MFN 06-257

**Subject: Response to Portion of NRC Request for Additional Information
Letter No. 40 Related to ESBWR Design Certification Application –
ESBWR Probabilistic Risk Assessment – RAI Numbers 19.1-8,
19.1-17, 19.2-6, 19.2-10, 19.2-13 and 19.2-18**

Response to Portion of NRC Request for
Additional Information Letter No. 40
Related to ESBWR Design Certification Application
ESBWR Probabilistic Risk Assessment
RAI Numbers 19.1-8, 19.1-17, 19.2-6, 19.2-10,
19.2-13 and 19.2-18

Figure 6.2-28. Vacuum Breaker Design Features

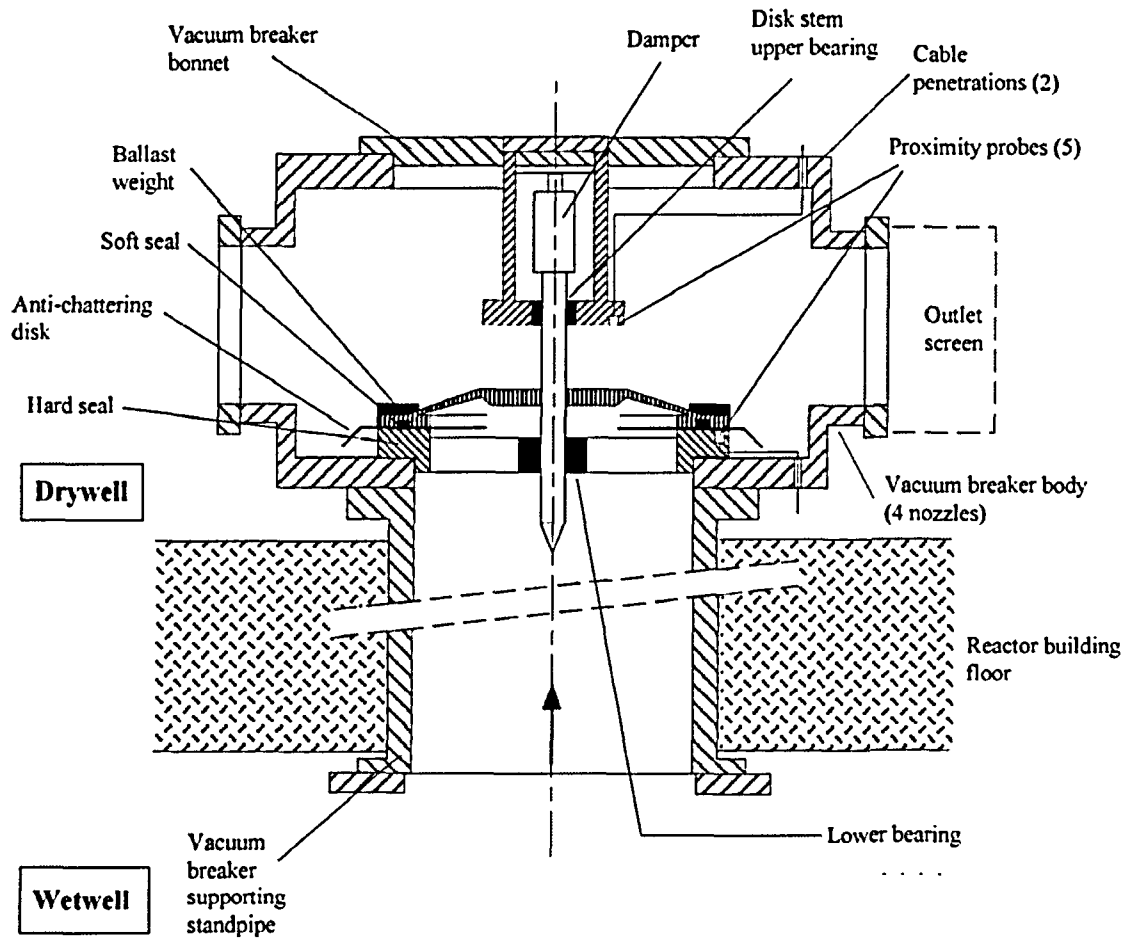
Provide additional information regarding the drywell to suppression chamber vacuum breakers, including drawings showing the vacuum breaker, proximity/position sensors, and DC motor-operated valve that would provide isolation if the vacuum breaker sticks open or leaks in its closed position (as described in Section 4.18.3.1 of the PRA).

DCD Section 6.2.1.1.2, fifth paragraph under the heading “Drywell” provides description of the drywell-to wetwell vacuum breaker and the upstream isolation valve. This paragraph will be revised to read as follows:

“Vacuum breakers are provided between the DW and WW. The vacuum breaker is self-actuating valve, similar to a check valve. The purpose of the DW-to-WW vacuum breaker system is to protect the integrity of the diaphragm floor slab and vent wall between the DW and the WW, and the DW structure and liner, and to prevent back-flooding of the suppression pool water into the DW. The vacuum breaker is provided with redundant proximity sensors to detect its closed position. On the upstream side of the vacuum breaker, a DC solenoid operated ~~butterfly~~ isolation valve designed to fail-close is provided. The vacuum breaker is illustrated in Figure 6.2-28. During a LOCA, when the vacuum breaker opens and allows the flow of gas from WW to DW to equalize the DW and WW pressure and subsequently does not completely close as detected by the proximity sensors, a control signal will close the upstream ~~butterfly~~ isolation valve to prevent extra bypass leakage due to the opening created by the vacuum breaker and therefore maintain the pressure suppression capability of the containment. Redundant vacuum breaker systems are provided to protect against a single failure of vacuum breaker, i.e., failure to open or failure to close when required. The design DW-to-WW pressure difference and the vacuum breaker full open differential pressure is given in Table 6.2-1.”

Figure 6.2-28 shown below will be added in DCD Tier 2.
